I.A. MEMORANDUM

SUBJECT: Planning & Public Works Committee Meeting Summary
Thursday, May 9, 2013

- B. **P.Z. 06-2013 Mercy Health System (Chesterfield Village, SE Quadrant):** A request for an ordinance amendment to modify the boundaries of the “UC” Urban Core District to incorporate two parcels zoned “C-8” Planned Commercial District into the “UC” Urban Core District totaling 43.35 acres located north of Chesterfield Parkway and east of Elbridge Payne Rd. (19S531791, 19S531801, 18S210028, 18S210149, 18S210073, 18S210062, 18S220148, 18S220171, 18S220061, 19S531922, and 18S210138).

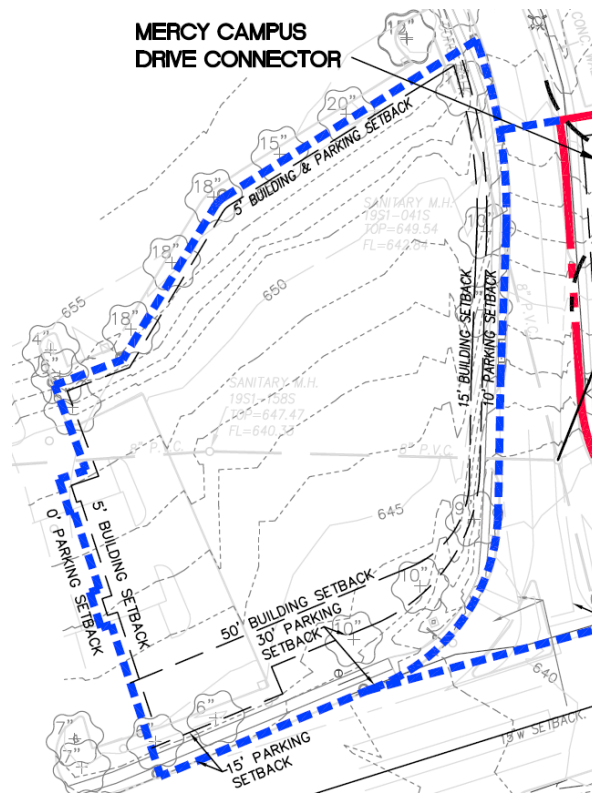
The proposed preliminary plan, depicted above, shows the removal of the existing “triangle” building with a new building being proposed in basically the same area. There are no development plans being proposed at this time for the new southwest parcel; however, the Petitioner wants to keep development options available for this parcel.

After discussions with the Planning Commission, the Petitioners are proposing the following parking setbacks for the southwest parcel (*depicted above*), 1281 Chesterfield Parkway East:

- 0' from the western boundary;
- 5' from the northern boundary;
- 10' feet from the eastern boundary; and
- 15-30' from the southern boundary.

Upon recommendation from the Planning Commission, the Petitioners have increased the building setback along Chesterfield Parkway from 30' to 50'. In exchange for this increased setback, they have reduced the building setback on the eastern boundary. This will give the Petitioners the same amount of developable area but will allow them to push the building further north and east providing an increased amount of area between the Brandywine development and a potential office building.

Councilmember Hurt expressed his concern with the access on the south side of the site.

The City reserves the right to remove the proposed signaled access point on Chesterfield Parkway, or change it to a right turn in/right turn out, if the Petitioner acquires the property to the east.

The vote to add language to the Attachment A that allows the City to reserve the right to remove or change the proposed access point on Chesterfield Parkway in the event the Petitioners acquire the property to the east failed by a vote of 2 – 2. (Councilmembers Fults and Grier voted “no”).

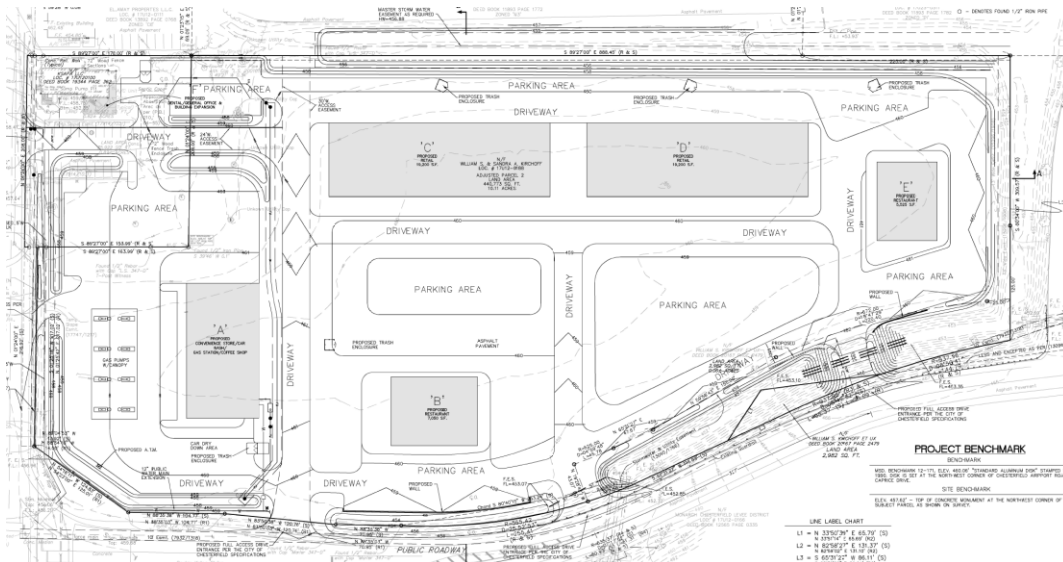
The proposed Preliminary Plan (*depicted above*) shows most of the major changes on the west side of the site. The other major change relates to Building E on the east side of the site, where the Petitioners are proposing a setback change from Edison Road from 125 feet to 65 feet. The requested setback change is to allow for more flexibility in the design to accommodate future users.

- A separate setback for the gas station canopy to be 50 feet from Long Road.
- An allowance to have an ATM located within the setbacks on the southwestern side of the gas station.
- Addition of the dental office building, which facilitates changes to the access.

The Petitioners are proposing a right-in only access into the service station. They are retaining the cross access requirements to the north and the storm water channel has been moved further to the east to prevent the internal drive from crossing it.

Councilmember Flachsbart suggested that the ATM be placed inside the building or on the corner of the building.

Chair Fults noted that the site was granted full access to Long Road through an agreement from 2001; however, she has serious concerns about such access as it allows traffic to cross five lanes of traffic. She then asked whether the 2001 agreement also allowed the three accesses along Edison being shown on the Preliminary Plan. Mr. Wyse confirmed that the agreement allows these three accesses.

Councilmember Hurt noted that the site has two access points within 330 feet on Edison Avenue and two access points on Long Road. He does not want any access points on Long Road and prefers only two access points on Edison Avenue with nothing closer than 380 feet. He added that he does not have a big concern over the proposed use.

- Regarding Building E, the proposed setback change from 120 feet to 65 feet from Edison was requested to make it consistent with the other setback requirements along Edison Avenue. If the Council wants to maintain the 120-foot setback, they are agreeable to it.
